The purpose of this notification is to communicate a circuit revision change to the CoolRunner™ XPLA3™ family of CPLD devices.

Design Circuit  
Revision Code

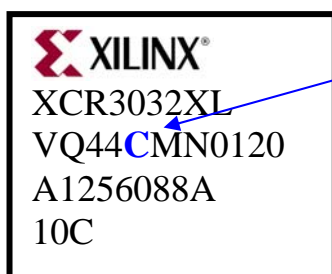
The design circuit revision code on the package topmark can be found as shown below.
